SOUTHWEST BIKEPATH CULVERT REPLACEMENT AT WAITE CIRCLE - 2019

CITY OF MADISON, WI

CITY PROJECT NO. 8466

ADDENDUM 1
8/29/19
CHANGED ENTIRE
DRAWING

**CIVIL
 PROPOSED
 RESTORATION PLAN**

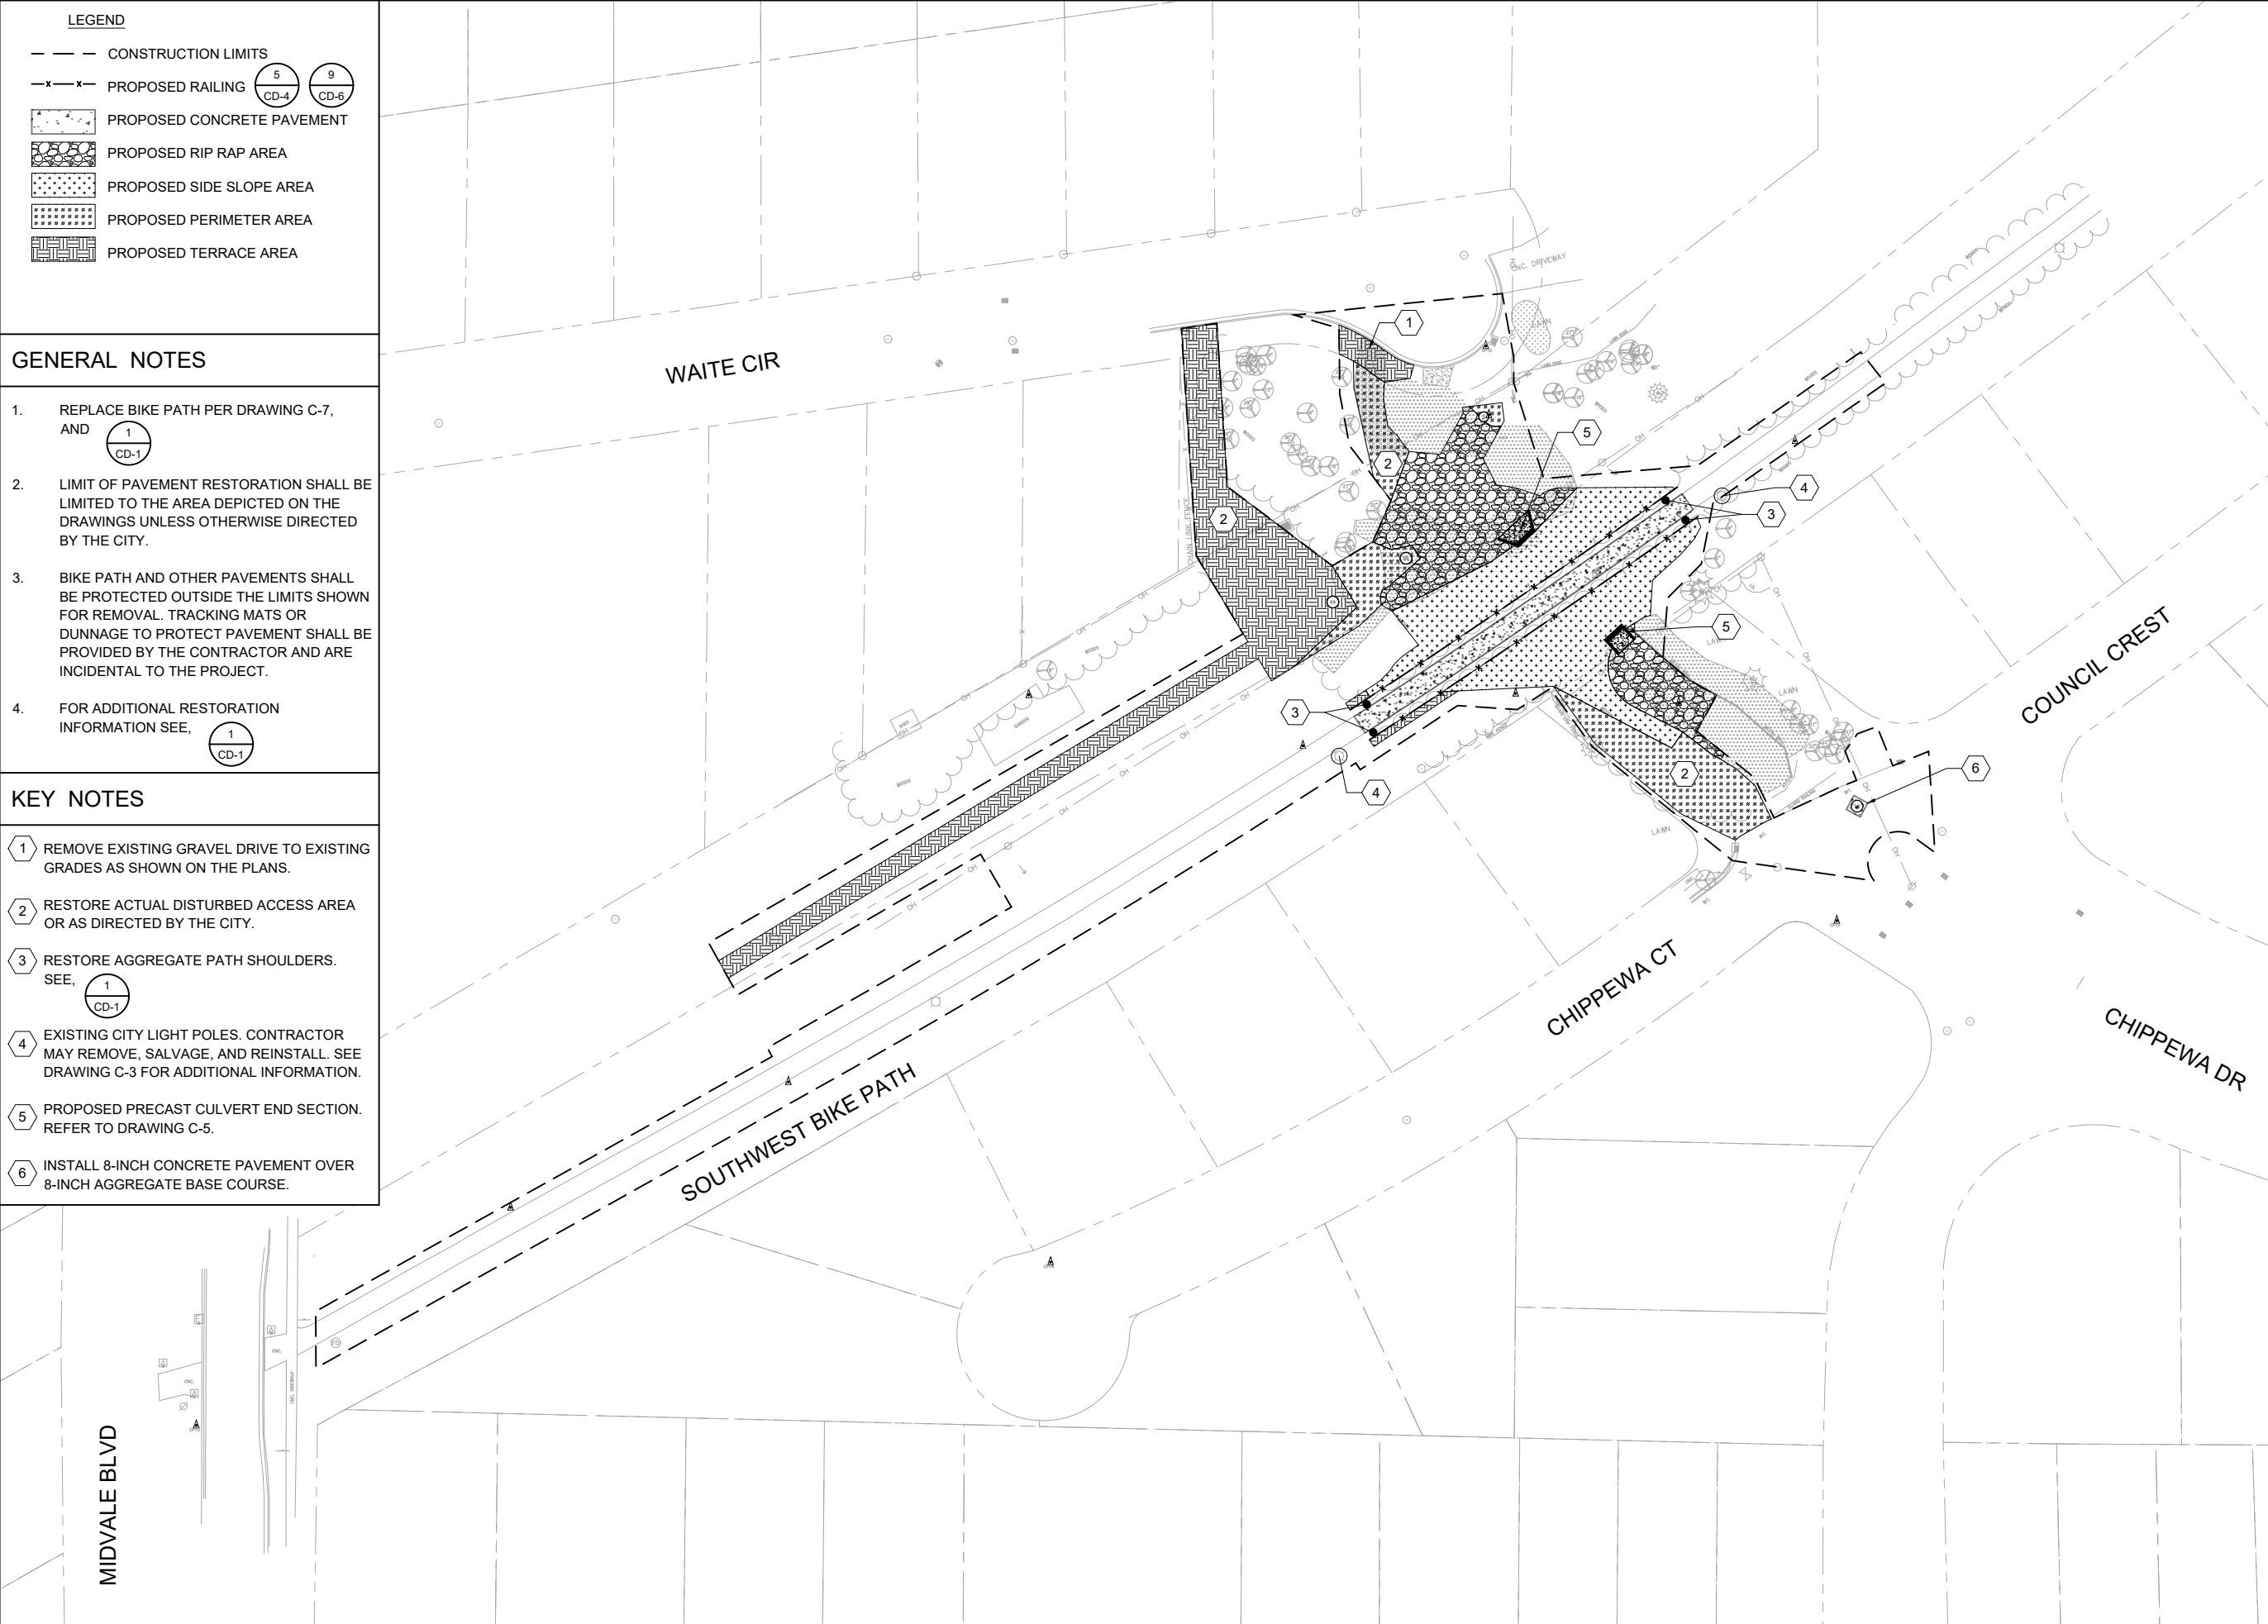
**ADDENDUM 1
 CHANGED
 ENTIRE
 DRAWING**

**CIVIL
TYPICAL SECTION**

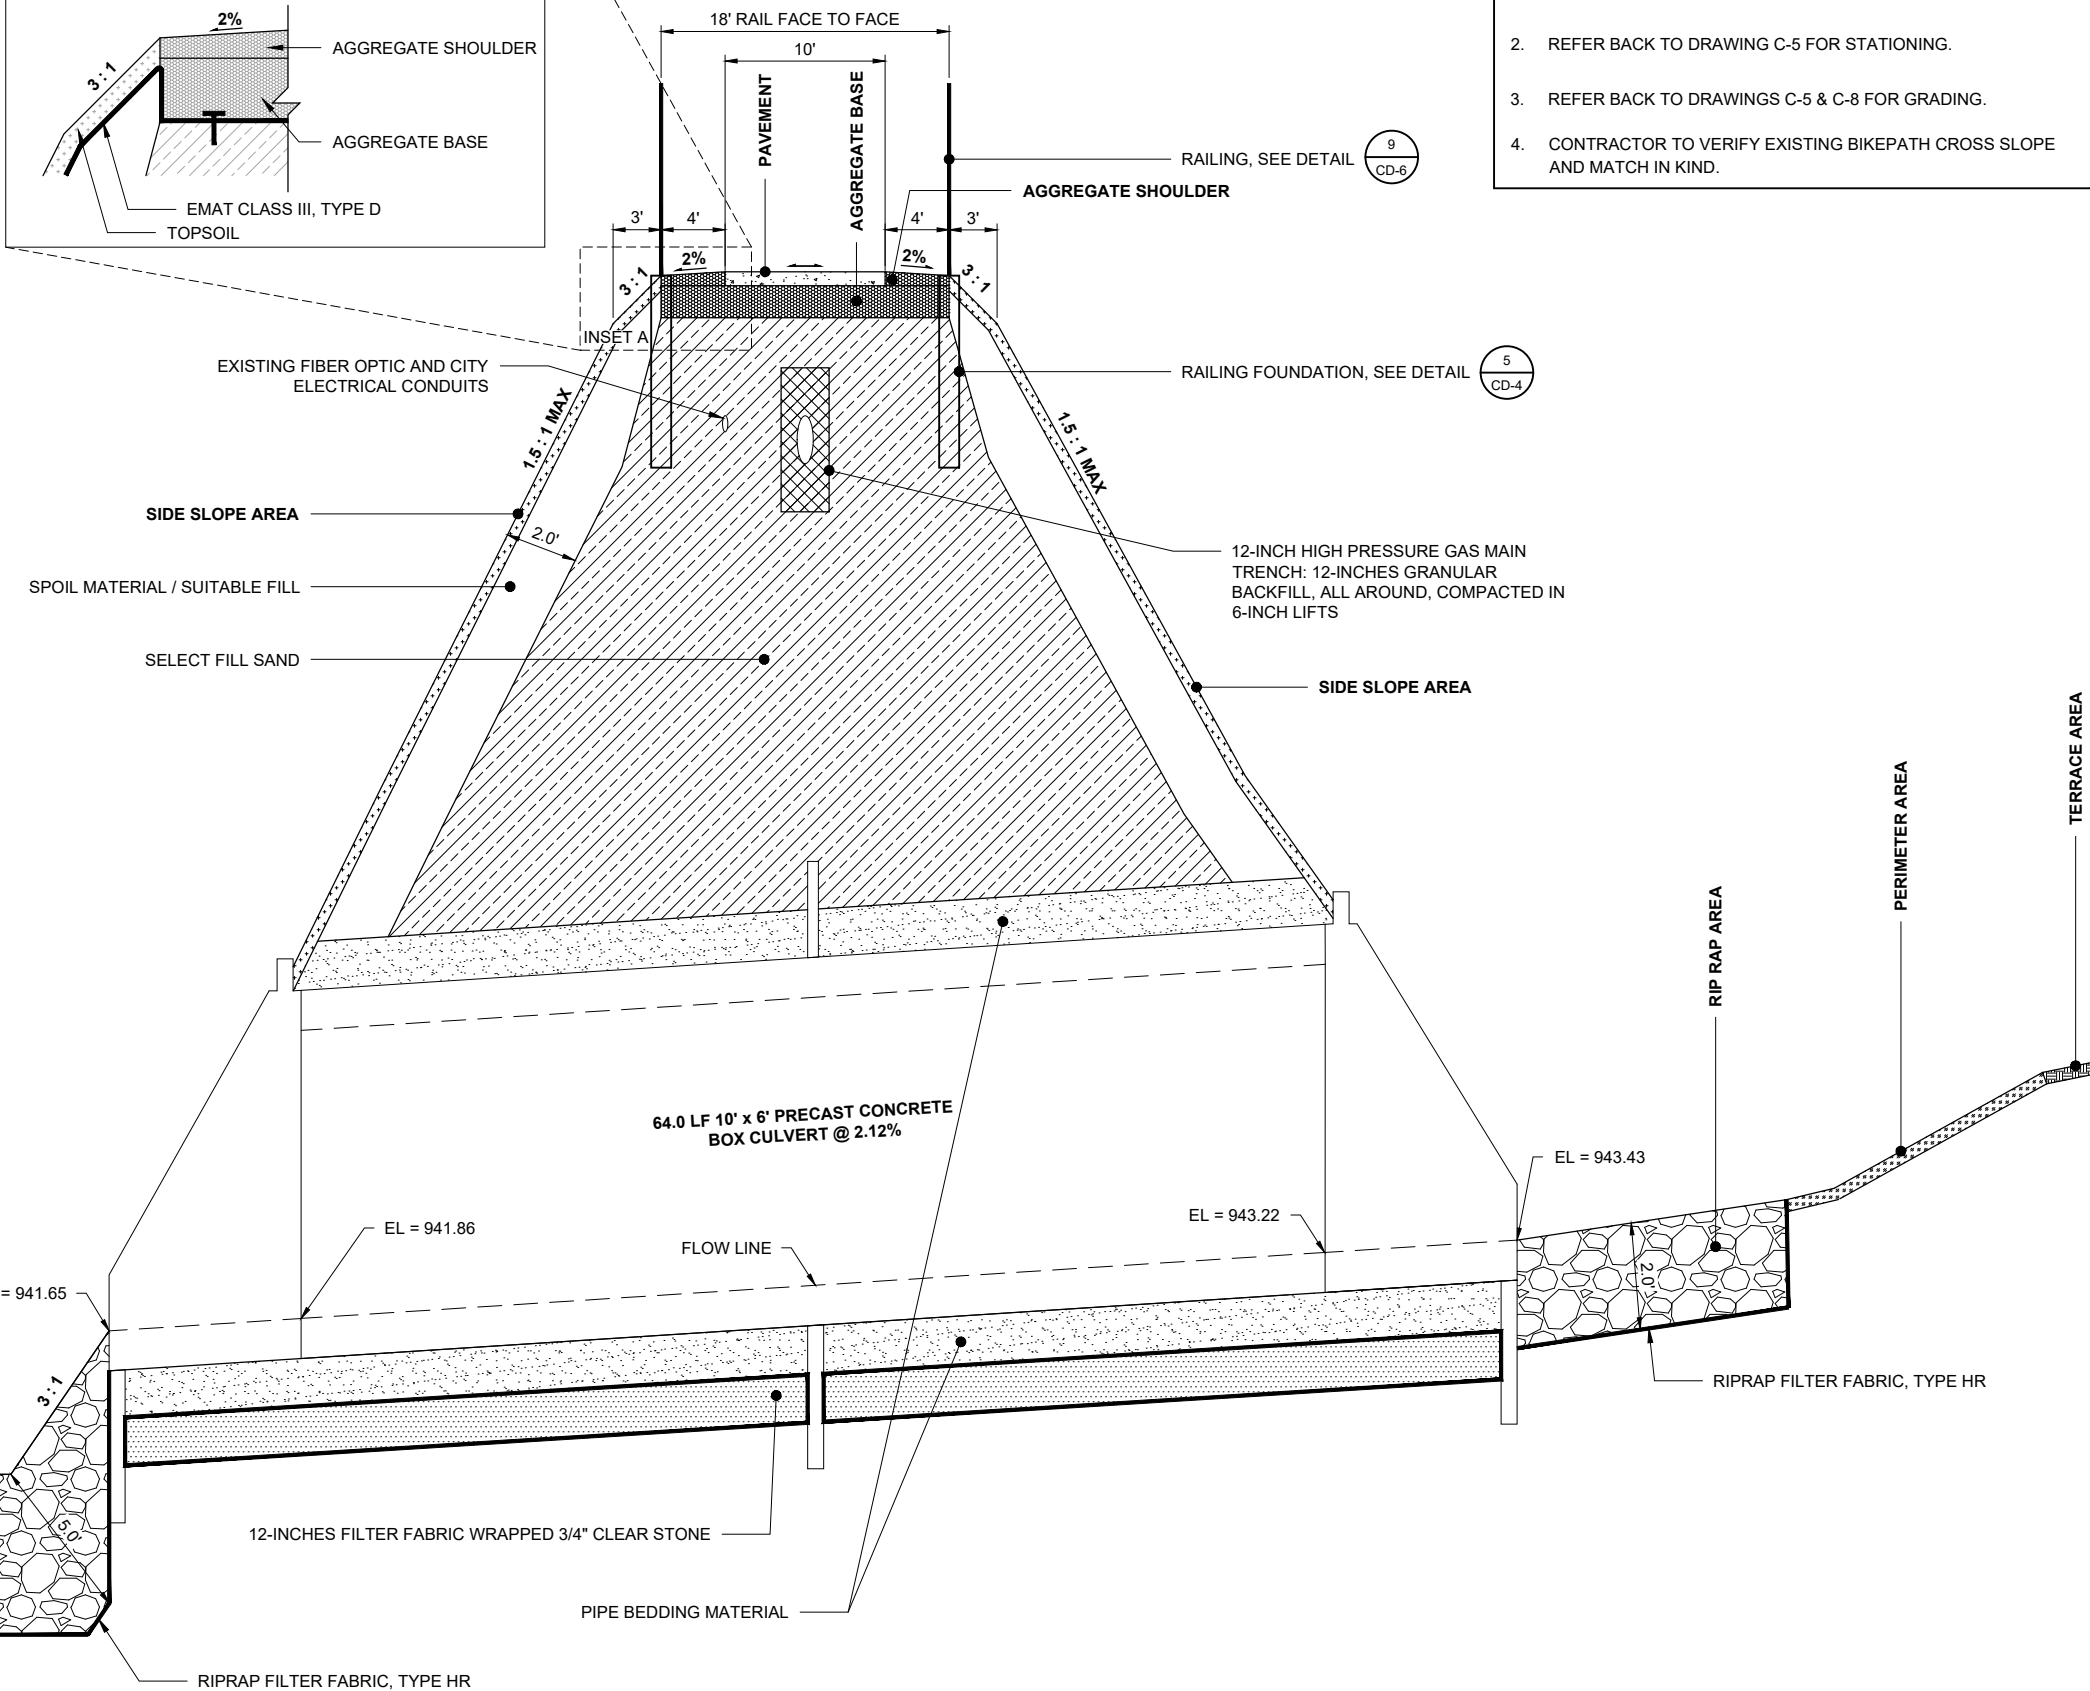
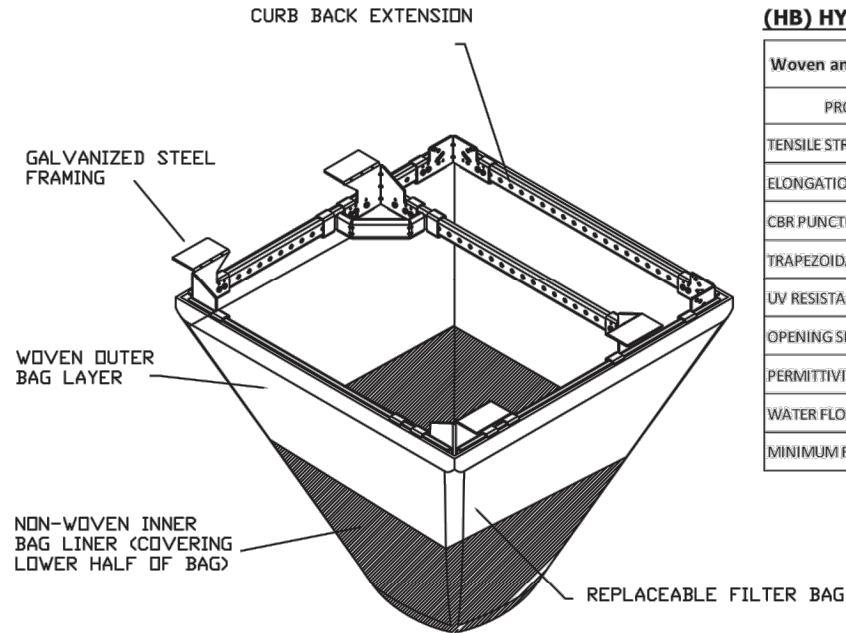
**ADDENDUM 1
CHANGED
ENTIRE
DRAWING**

**CIVIL
 STANDARD DETAILS
 - MMSD**

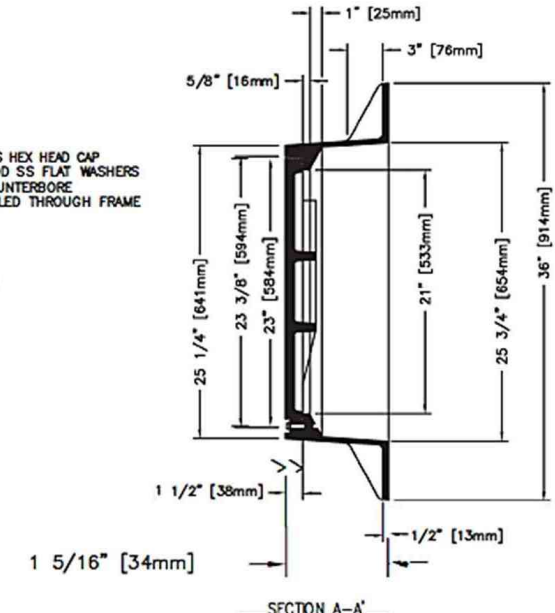
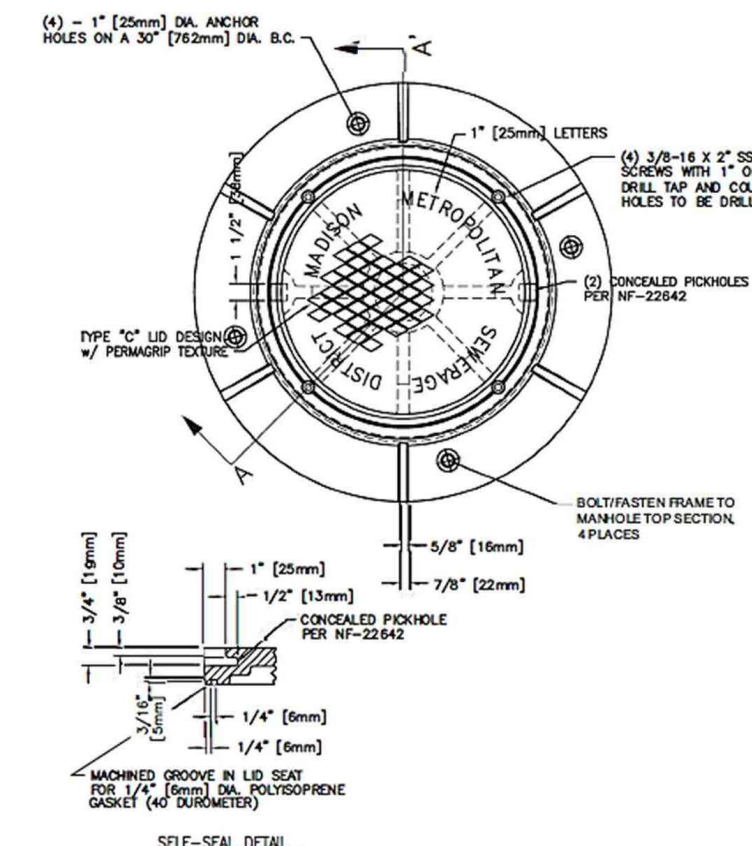
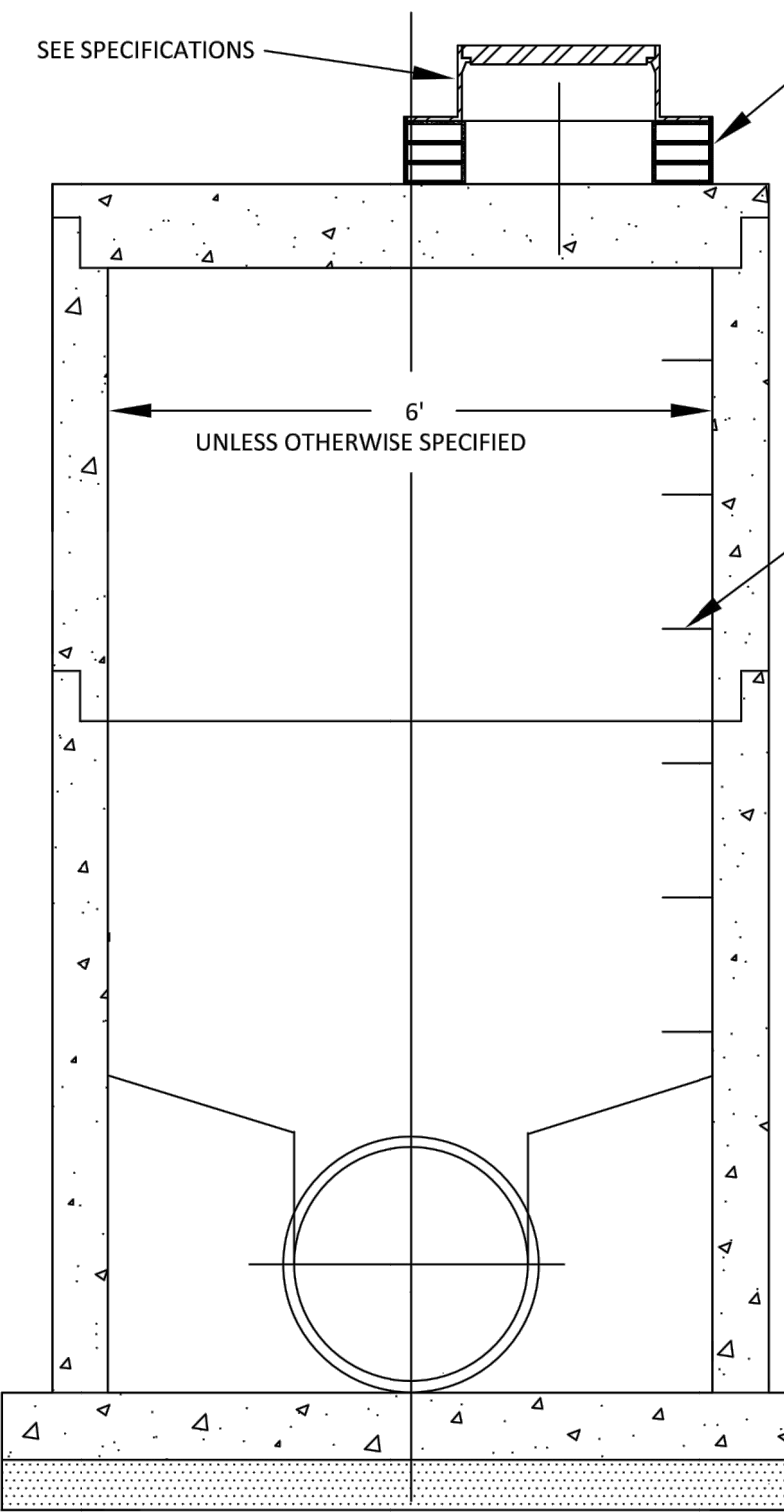
**ADDENDUM 1
 CHANGED DETAIL
 NUMBER AND
 DRAWING NUMBER**
